Enclosure 5
NRC Whitepapers
Meeting Summary of the 12/10/08 Reactor Oversight
Process Working Group Public Meeting
Dated December 30, 2008

Staff White Paper on NEI 99-02 Guidance Changes for MSPI for Clarification of
Planned UA Expectations

Staff White Paper for Long-term MSPI Baseline Unavailability Options

Staff White Paper
EDG Component Boundary

Figure 1
MSPI Scoping

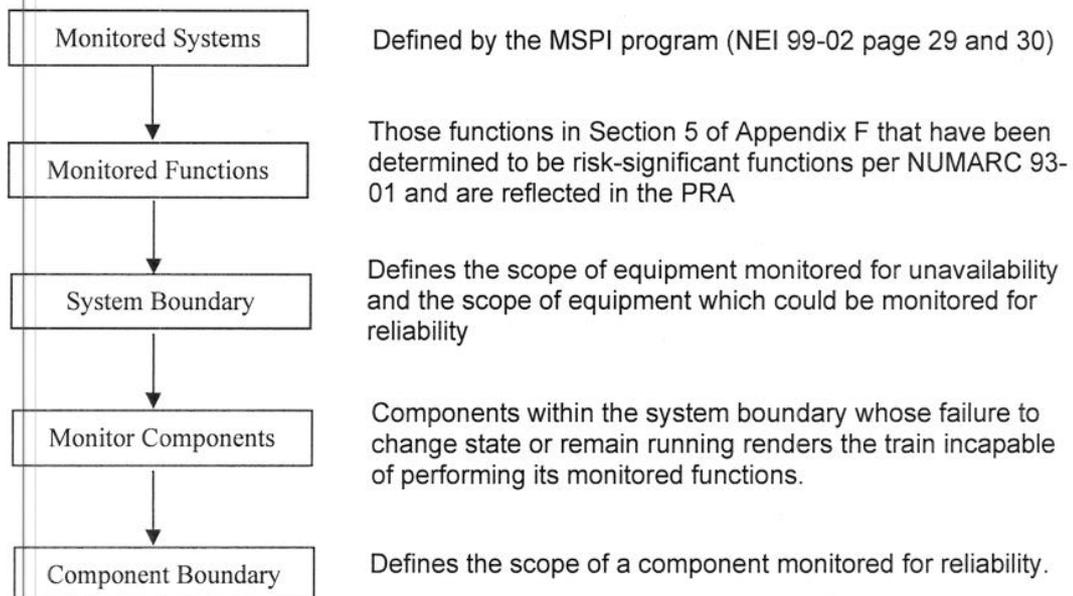
The treatment of the failures associated with the EDG fuel oil system is unclear as the fuel oil system is stated as being within the boundary of the EDG super component but the fuel oil transfer pumps (which are part of the fuel oil system) are stated as not being monitored.

The fuel oil system (including local or day tank) is identified as being part of the EDG super component (within the component boundary) while the fuel oil transfer pump is within the system boundary, but is not considered to be a monitored component. Its exclusion is stated as being due to the difficulty in obtaining accurate estimations of demands and run hours (due to the auto start and stop feature of the pump) and due to the expected small contribution to the index (NEI 99-02, Section F.5). Although Section F.5 states that the EDG Fuel Oil Transfer Pumps are exempt from unreliability monitoring, it implies that these pumps would normally have been monitored except for difficulties in data tabulation and in some cases for plants with multiple redundant pumps, their low risk significance. Additionally they are monitored for contribution to train unavailability only if an EDG train can only be supplied from a single transfer pump. Section F.5 notes that there are configuration differences where the capability may exist to supply an EDG from redundant transfer pumps which would result in the contribution to the EDG MSPI from these components to be small compared to the contribution from the EDG itself.

The staff proposes to align the fuel oil system issue with the philosophy of Section F 2.1.3 which states that a support component that solely support the operation of the monitored component should be considered part of the component boundary. Therefore, if a portion of the fuel system (including the fuel oil transfer pumps) that uniquely supports a single EDG results in the failure of the EDG, then that failure will be considered to be within the EDG component boundary and will be recorded as a failure against the EDG. This approach allows flexibility in the definition of the fuel oil system boundary such that the various plant configurations can be accommodated. If the failure of the failure of the fuel oil transfer pump results in a depleted day tank and the inability of the EDG to perform its mission (assume tank depletion occurs during an actual demand), then this event would be an EDG failure. If the failure of the fuel oil transfer pump does not result in an EDG failure, then no EDG failure would be recorded.
